PRODUCT CHANGE NOTIFICATION

Bourns® Model 2035, 2037, 2027 & 2039 Gas Discharge Tubes Series

Changes to Reel Hub Packaging

GDT2303

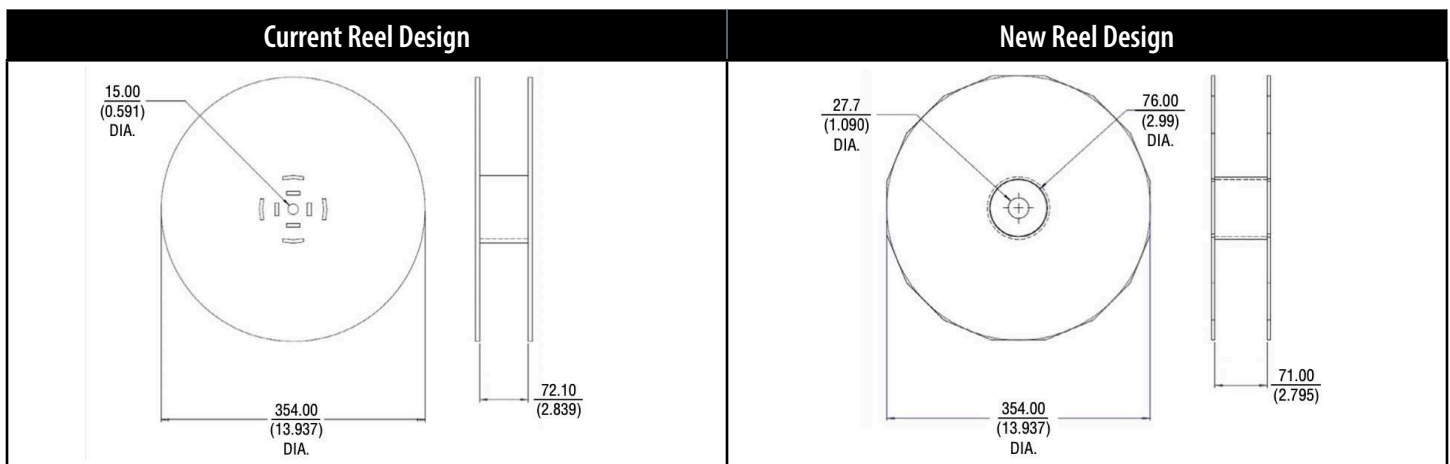
Riverside, California – March 22, 2023 – The reel packaging for select Axial Leaded Bourns® Model [2035](#), [2037](#), [2027](#) and [2039](#) Series Gas Discharge Tubes is being improved. The reels used to pack these gas discharge tubes in their axial leaded tape & reel packing configuration will have the reel changed to use a plastic or metallic (optional) hub. This change will minimize the friction between the support shaft and the reel in automatic lines, decreasing the tension in the tape and thereby optimizing performance.

The change in the reel's hub will have no effect on the form, fit, function, quality, or reliability of the products themselves. A list of affected part numbers is provided below.
